KINGSTON FOSSIL PLANT (KIF) - ANNUAL ASH POND DIKE STABILITY INSPECTION

ANNUAL ASH POND DIKE
STABILITY INSPECTION

Prepared by: John Albright
Date: October 25, 2002

Photo 4 - Ash Pond Spillway Discharge

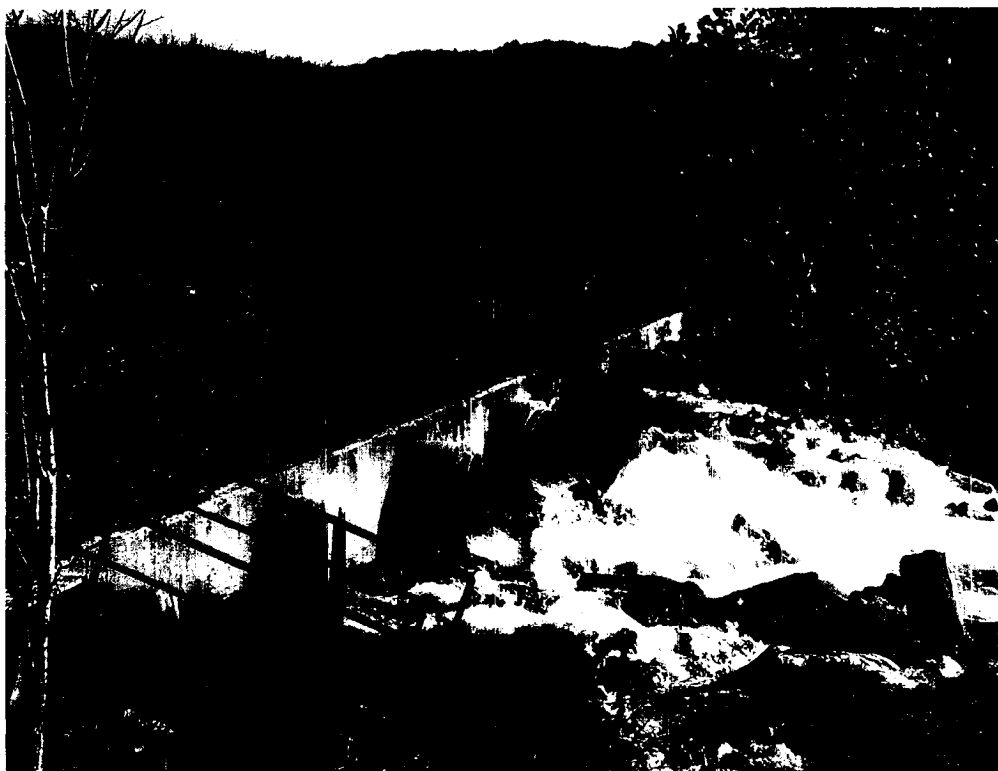
The ash pond discharge spillways are in good condition with no noticeable erosion (see Photos 4 and 5). A recent flow experiment plugged all of the ash pond discharge spillways at their outlets overnight. When the plugs were released, some of the rip-rap at the discharge was washed away and later replaced.

- Future flow control of the ash pond discharge should only be done by raising the standpipes. The outlets must not be plugged. Plugging the outlets puts the joints in the concrete pipe under pressure they were not intended to withstand. This pressure could cause the joints to leak and wash out a portion of the dike causing the dike to fail.
- Dredge the Coal Yard Drainage Basin to restore its design contours and protect the pumps from further damage. There is an estimated 2,200 cubic yards of sediment in the original pond and an extra 2,750 cubic yards in the "V" section that needs to be removed as soon as reasonable. See the attached copy of 10W225-1.

**COAL YARD RUNOFF POND
DISCHARGE PIPE UPGRADE
PIPE ROUTE & GRADING PLAN**

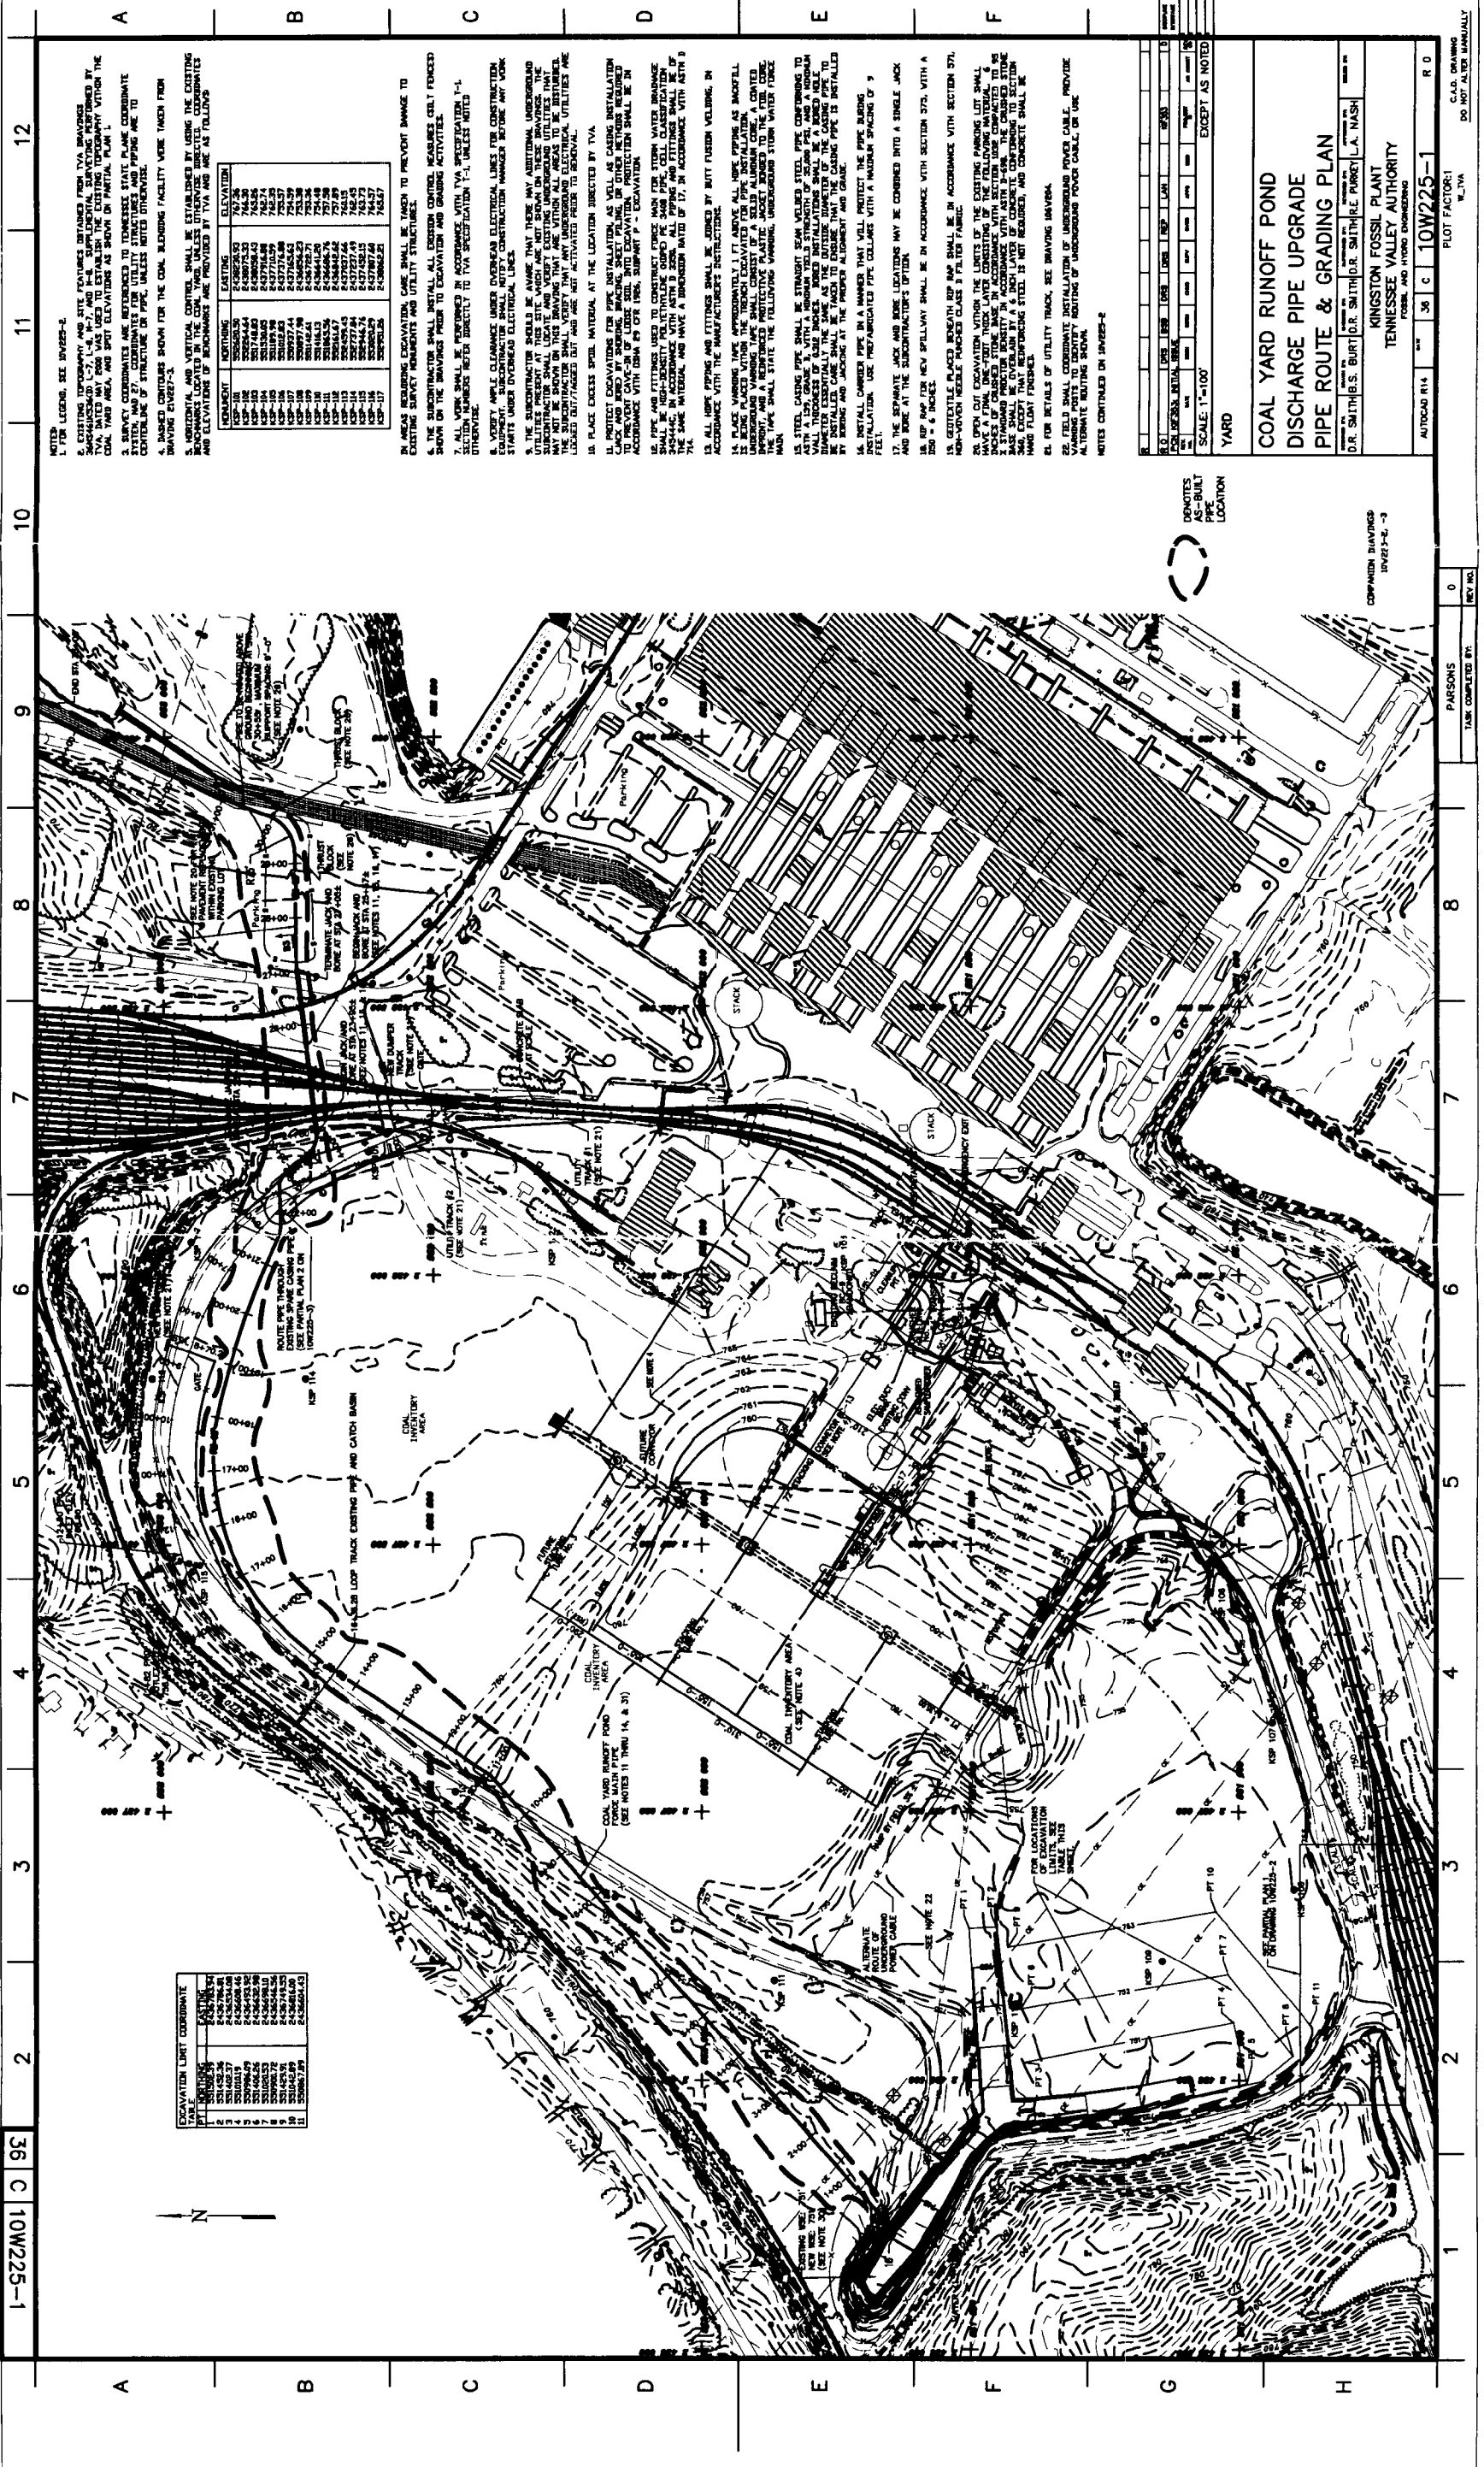
below the first pump start switch and the platform was grounded. The basin was sounded at 5 places and found to have a depth of 2.7 feet average when the water was at elevation 751. This indicates the sediment in the bottom occupies 3.3 feet of the basin's storage capacity. Since it was dredged just over a year ago, we forecast the basin will need to be dredged annually. The bottom of the pond should be no higher than elevation 745. Elevation 745 allows 2 feet of clearance below the pump intakes to prevent the pumps from pumping solids; the elevations indicate the pumps have been pumping solids for some time. In addition, the "V-shaped" pond extensions added during the summer of 2001 to increase the pond storage volume were visually undetectable. TVA drawing 10W225-1 shows the pond and its intended bottom contours.
